Addendum No. 5

Project: Guilford County Law Enforcement Center Renovation
Rebid Event # 629

Addendum Date: August 14, 2018

2226
LEVEL 2 - MECHANICAL -
FLOOR PLAN - ROOF PLAN
 1/16"=1'-0"

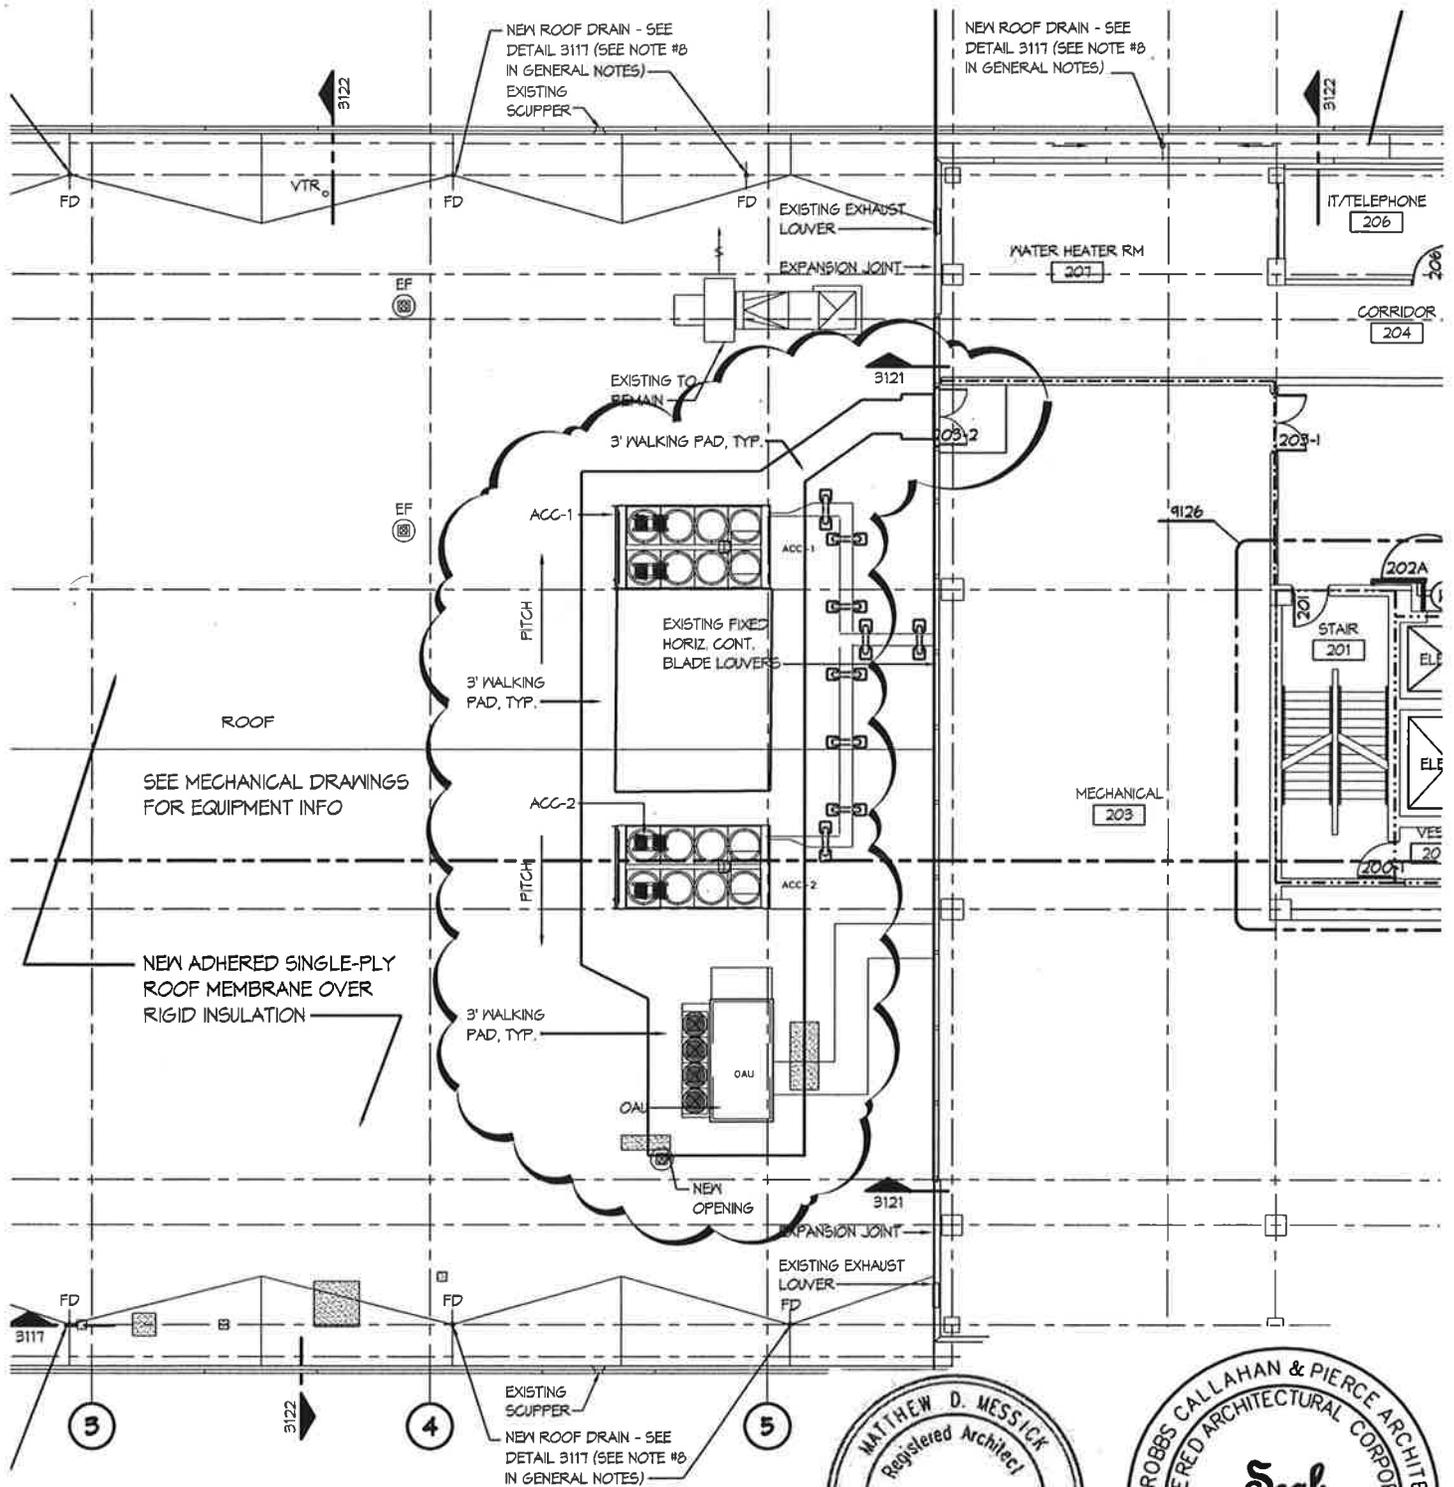
11.	A2.2	2226 Level 2 – Mechanical – Floor Plan – Roof Plan: Provide roof walkway pads as specified in Section 07 54 00 and as shown on Addendum Drawing ADD 5-1. (Attached)

3111 HIGH ROOF PLAN

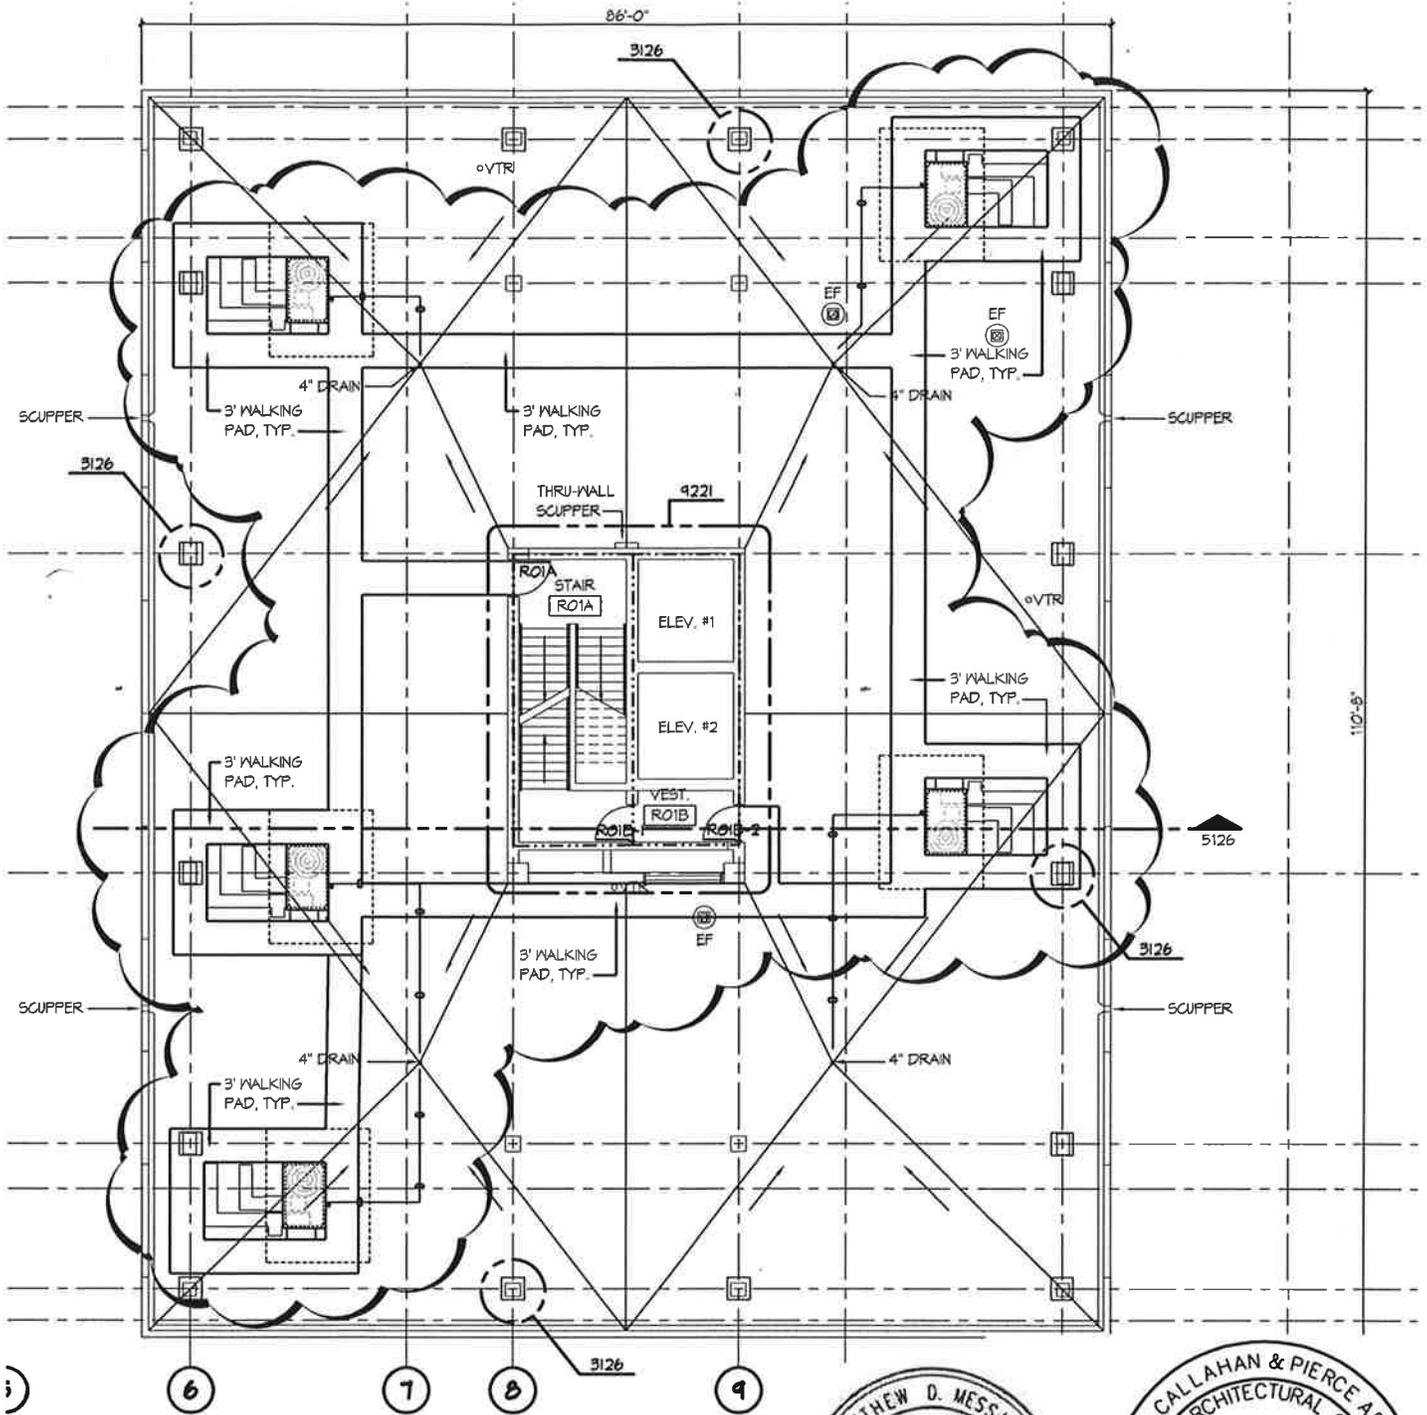
12.	A3.1	3111 High Roof Plan: Provide roof walkway pads as specified in Section 07 54 00 and as shown on Addendum Drawing ADD 5-2. (Attached)
13.	A7.1	7123 Elevation @ Men 106 & Women 107: Show 6'-10" high ceramic tile wainscot to agree with Room Finish Schedule on drawing A11.3.
